## Landscape Referral Response

<b>Application Number:</b>	Mod2022/0413
<b>Date:</b>	03/11/2022
<b>Responsible Officer:</b>	Adam Susko
<b>Land to be developed (Address):</b>	Lot 7 DP 1020015 , 49 Frenchs Forest Road East FRENCHS FOREST NSW 2086

Plan 1. Approved landscape works fronting Warringah Road

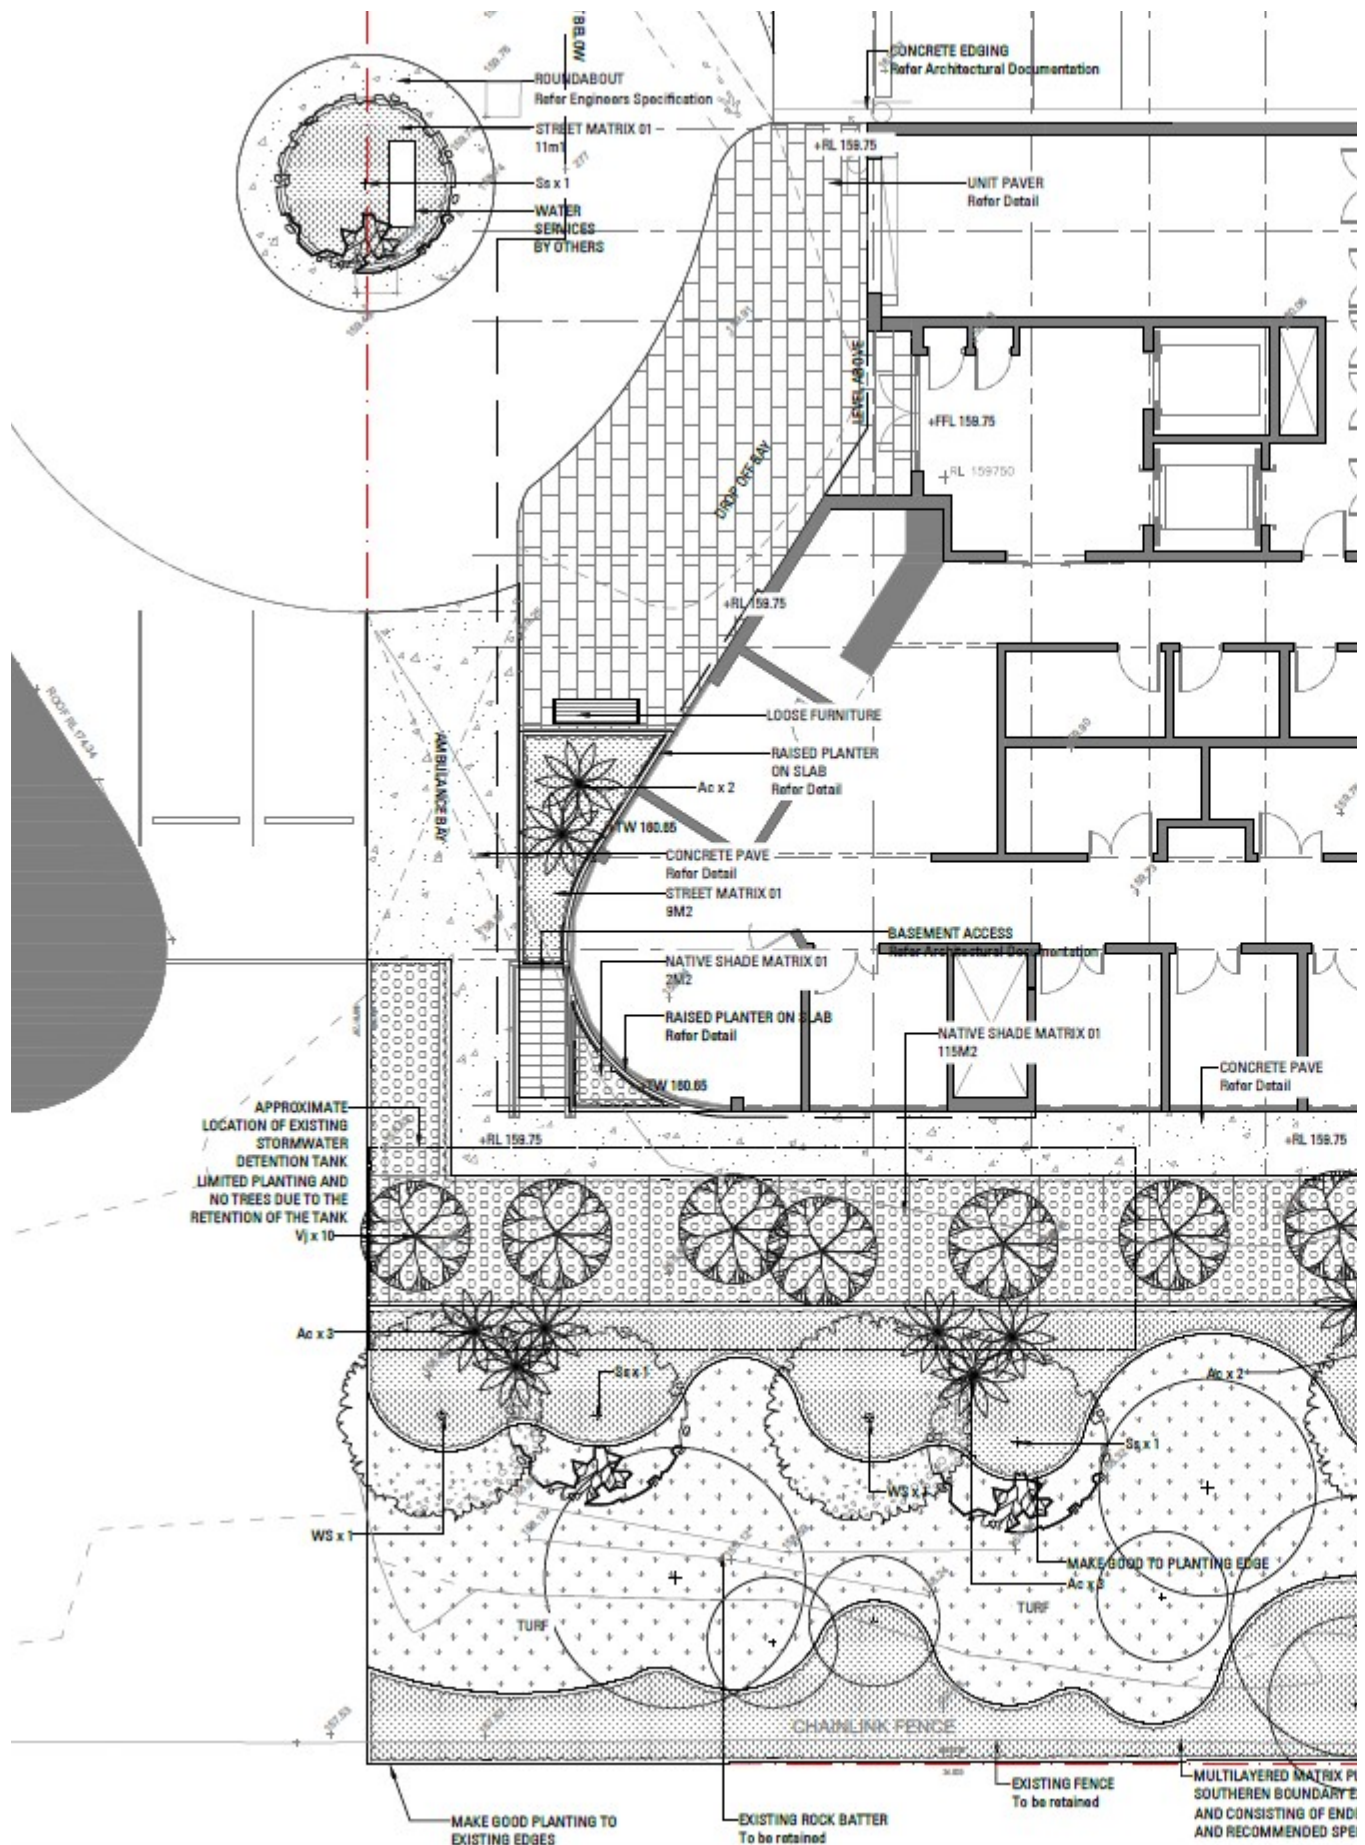
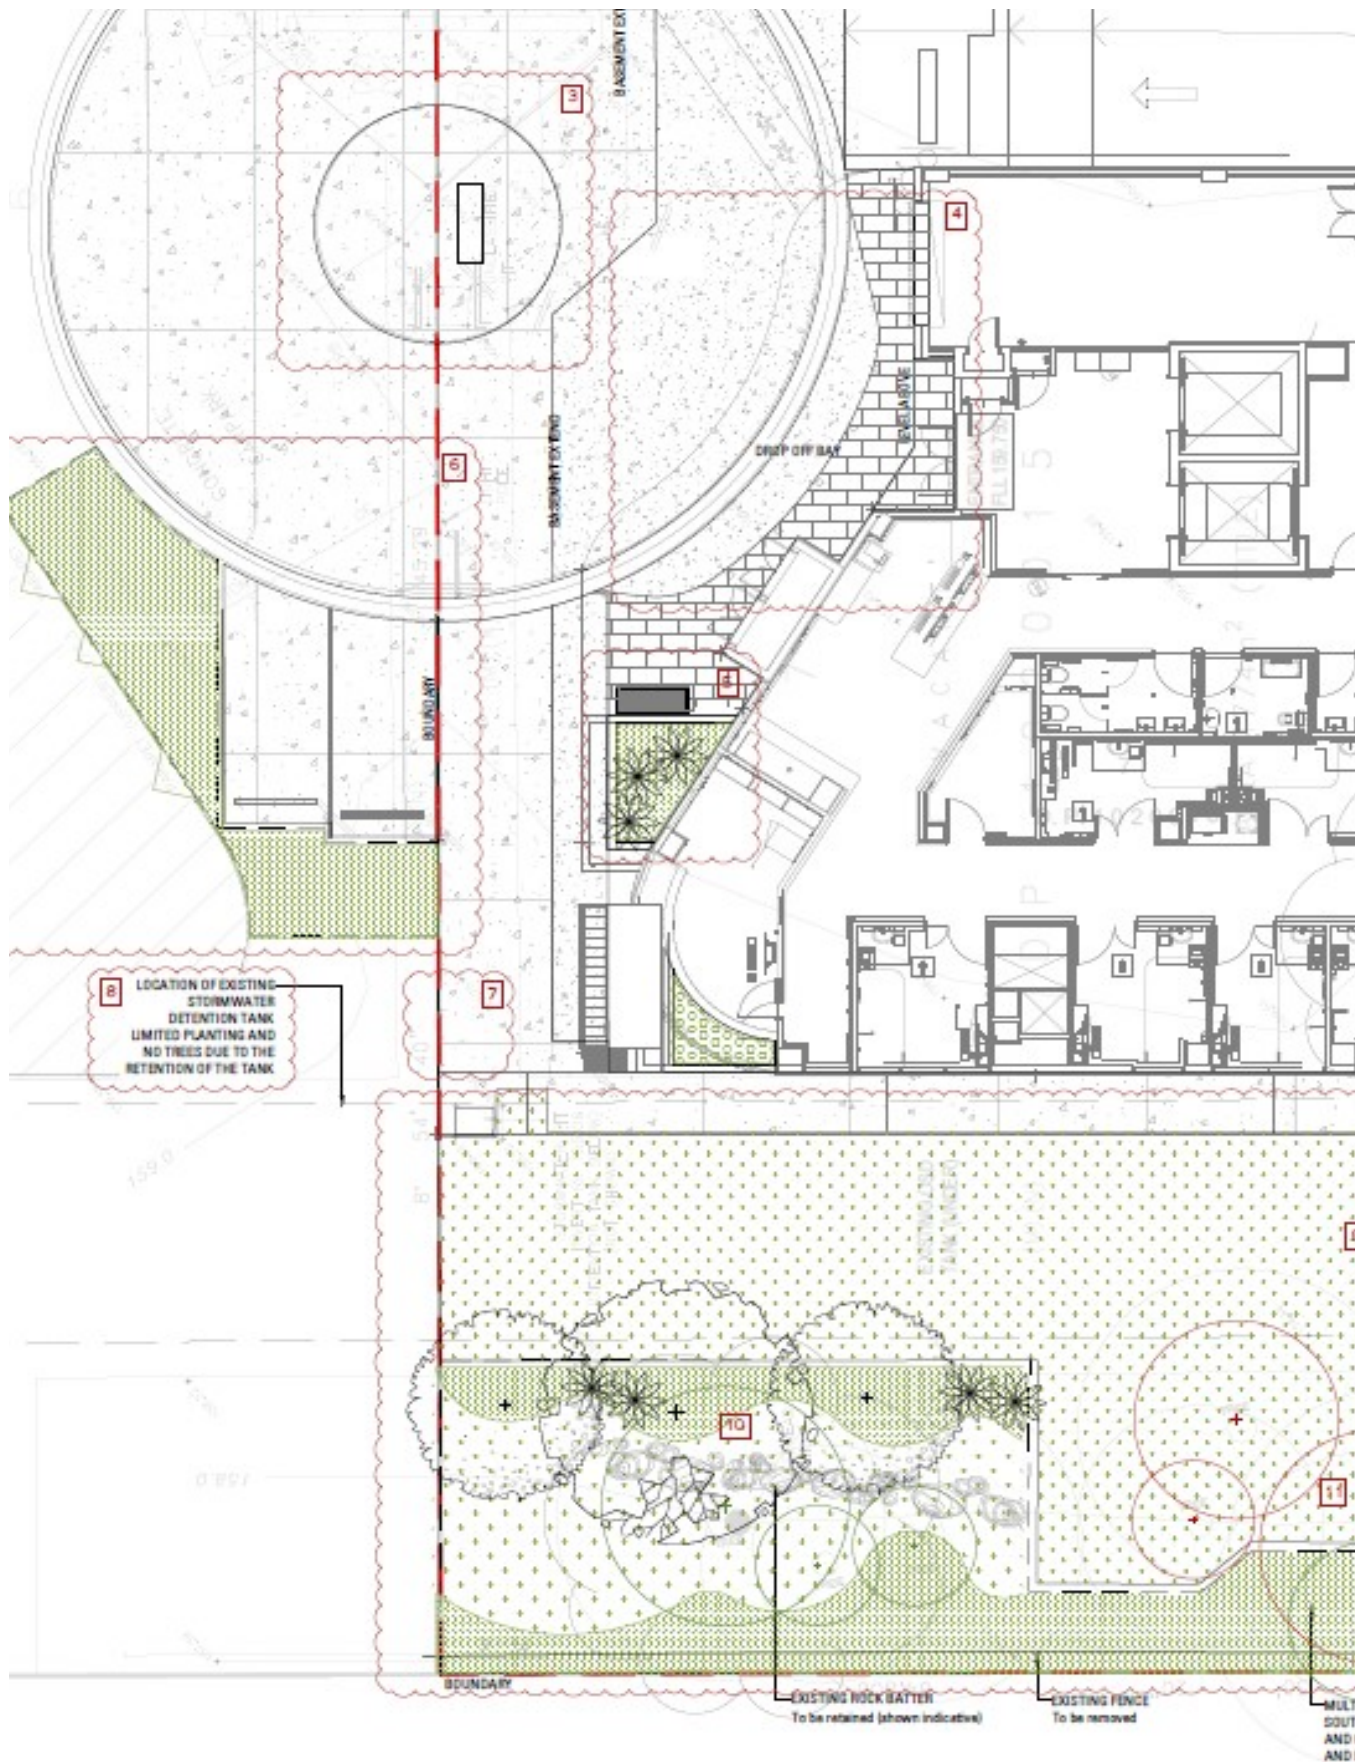
The Modification proposes significant amendment to the approved landscape works, particularly along the Warringah Road frontage and the eastern boundary.

The SEE indicates that the removal of trees, shrubs and groundcovers from the approved plans is required to accommodate access for Ausgrid. It is also apparent that the detention tank has doubled in

The amended landscape plans indicate removal of a further 3 existing trees along the Warringah Road frontage and deletion of 6 replacement trees.

It would be of assistance if details of the required access for Ausgrid were provided with the application to confirm that the extent of area being deleted from the landscape planting is actually required.

The removal of 3 additional trees and deletion of 6 replacement trees in addition to the the shrubs and groundcovers proposed to be deleted could not be supported without clarification of the access requirements, which presumably caters for truck access and turning radii.

At this stage, the proposal is not able to be supported with regard to landscape issues die to lack of information to make an assessment.
